**SUBDIVISION,  
PLANNED UNIT DEVELOPMENT, &  
REZONING STAFF REPORT****Date: August 20, 2015**

<b><u>APPLICANT NAME</u></b>	Daniel Clark
<b><u>SUBDIVISION NAME</u></b>	Mack Manufacturing Subdivision, Resubdivision of
<b><u>DEVELOPMENT NAME</u></b>	Mack Manufacturing Subdivision, Resubdivision of
<b><u>LOCATION</u></b>	7205 Bellingrath Road (East side of Bellingrath Road at the East terminus of Will Casher Lane)
<b><u>CITY COUNCIL DISTRICT</u></b>	Council District 4
<b><u>PRESENT ZONING</u></b>	I-2, Heavy Industry District, and R-1, Single-Family Residential District
<b><u>PROPOSED ZONING</u></b>	I-2, Heavy Industry District
<b><u>AREA OF PROPERTY</u></b>	1 Lot/10.9± Acres
<b><u>CONTEMPLATED USE</u></b>	<p>Subdivision Approval to create one legal lot of record from an existing legal lot of record and two existing metes-and-bounds parcels; Planned Unit Development to amend a previously approved Planned Unit Development to allow multiple buildings on a single building site, accommodate existing and future businesses, and reduced front landscaping requirements, and Rezoning from R-1, Single-Family Residential District, to I-2, Heavy Industry District, to accommodate an existing and f

# SITE PLAN

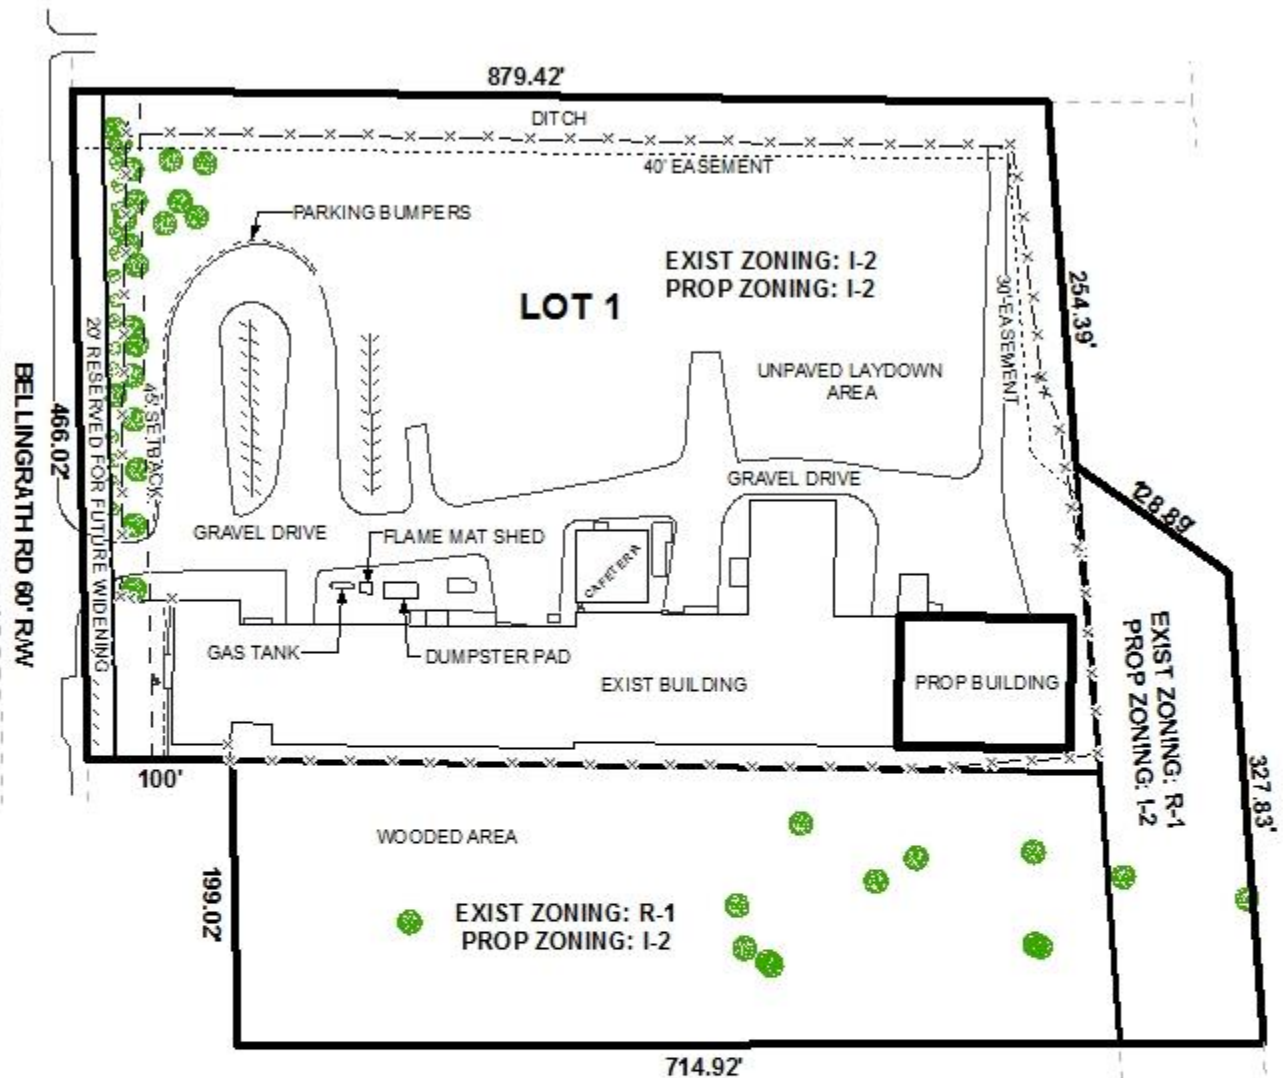
A review of the preliminary Subdivision plat and the site plans for the PUD and Rezoning indicates that one of the two parcels (R023802102000176) proposed to be added to the site is not included in its entirety. Only that portion directly adjacent to the East of the proposed new South line of the site is included. The applicant purchased this portion via a parceling sale without going through the proper Subdivision process. The complete parcel was land-locked and the sale produced a further smaller land-locked parcel not allowed by the Subdivision Regulations. In order to proceed with a detailed review of the applications presented, the entire parcel must either be included in all three applications, or it must be combined as a second lot in the Subdivision with a larger parcel (R023802103000001) to the South also owned by the seller which has access to two public streets (Ann Street and Helen Drive). However, this would require either the de-annexation of the remaining portion of Parcel R023802102000176, or the annexation of the larger parcel to prevent the creation of a lot partially in and partially out of the City limits.

**Subdivision:** Due to the fact that only a portion of an adjacent parcel is included, this application is recommended for holdover to the September 17<sup>th</sup> meeting to allow the applicant to include the remainder of Parcel R023802102000176 in the Subdivision, Planned Unit Development and Rezoning, or revise the Subdivision application to two lots to include that remainder with Parcel R023802103000001 as the second lot. Revisions, new labels and additional fees should be submitted no later than August 28<sup>th</sup>.

**Planned Unit Development:** Due to the fact that only a portion of an adjacent parcel is included, this application is recommended for holdover to the September 17<sup>th</sup> meeting to allow the applicant to include the remainder of Parcel R023802102000176 in the Planned Unit Development, Subdivision and Rezoning applications, or include that remainder with Parcel R023802103000001 as a second lot in a two-lot Subdivision. Revisions, new labels and additional fees should be submitted no later than August 28<sup>th</sup>.

**Rezoning:** Due to the fact that only a portion of an adjacent parcel is included, this application is recommended for holdover to the September 17<sup>th</sup> meeting to allow the applicant to include the remainder of Parcel R023802102000176 in the Rezoning, Planned Unit Development and Subdivision applications, or include that remainder with Parcel R023802103000001 as a second lot in a two-lot Subdivision. Revisions, new labels and additional fees should be submitted no later than August 28<sup>th</sup>.
